# Access Compliance Report

## Public Rights-of-Way

### (Curb Ramps)

Intersection ID: 8515	Main Street: ATANDO_AV	Cross Street: STATESVILLE_AV	Location: NE
ADA ID: 3F3D9DC7B6C3	Ramp Type: Combination1	Initial Pass/Fail: Fail	Overall Compliance: No
			Severity Score: 18.75

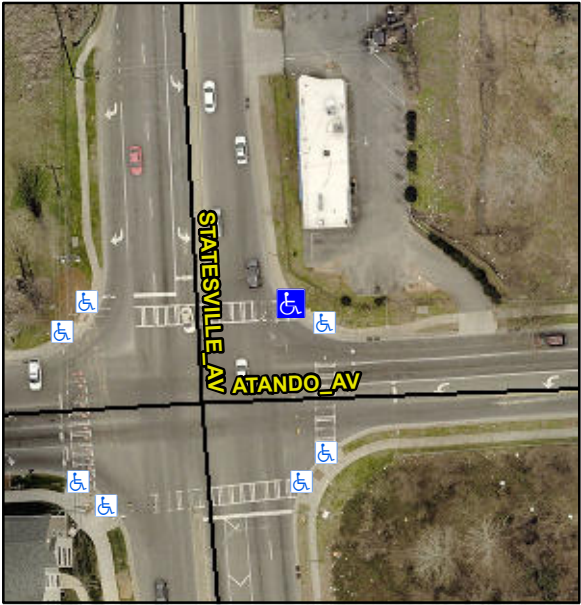
Codes/Mitigation Info/Possible Solution			Field Measurements/Component Compliance		
	Possible Solutions:		<b>Compliance</b>	<b>Description</b>	<b>Data</b>
	<b>Remove &amp; Replace Entire Ramp.</b>		<b>N/A</b>	Ramp Length LT (in)	<b>64.0</b>
			<b>No</b>	Ramp Width LT (in)	<b>33.0</b>
			<b>Yes</b>	Ramp Slope LT (%)	<b>5.7</b>
			<b>No</b>	Ramp XSlope LT (%)	<b>3.7</b>
			<b>N/A</b>	Ramp Length (in)	<b>26.0</b>
			<b>No</b>	Ramp Width (in)	<b>45.0</b>
	Surveyor Notes:		<b>N/A</b>	Flare Type LT	<b>N/A</b>
	<b>N/A</b>		<b>N/A</b>	Flare Slope LT (%)	<b>N/A</b>
			<b>N/A</b>	Flare Traversable LT?	<b>N/A</b>
	PROW/ADA:		<b>N/A</b>	Landing Length (in)	<b>N/A</b>
	<b>R304.5.1, R304.5.1, R304.5.3</b>		<b>N/A</b>	Landing Width (in)	<b>N/A</b>
			<b>N/A</b>	Landing Slope (%)	<b>N/A</b>
			<b>N/A</b>	Landing X Slope (%)	<b>N/A</b>
			<b>N/A</b>	Landing Curb? (Y/N)	<b>N/A</b>
			<b>N/A</b>	Shared Landing?	<b>N/A</b>
			<b>N/A</b>	Gutter Ponding?	<b>N/A</b>

<b>N/A</b>	Gutter Lip Ht (in)	<b>N/A</b>
			<b>N/A</b>	Painted X Walk1?	<b>Yes</b>
				X Walk 1 Direction	<b>To W</b>
				X Walk 1 Width (in)	<b>118.0</b>
				X Walk 1 Slope (%)	<b>0.2</b>
				X Walk 1 X Slope (%)	<b>2.3</b>
	Total Cost:	<b>\$ 1800.00</b>	<b>N/A</b>	Ramp inside XWalk1?	<b>Yes</b>
				Road Slope (%)	<b>N/A</b>
				Road X Slope (%)	<b>N/A</b>
				Clear Space?	<b>N/A</b>
				Clear Space to XWalk (in)	<b>N/A</b>
				Any Obstruction?	<b>N/A</b>
				Obstruction Type	<b>N/A</b>
				Storm Grate/Utility Hazard?	<b>N/A</b>
				Storm Grate/Utility Type	<b>N/A</b>
					<b>N/A</b>
			<b>Yes</b>	Surface Condition? (G/P)	<b>Good</b>
				Curb Slope (%)	<b>3.4</b>
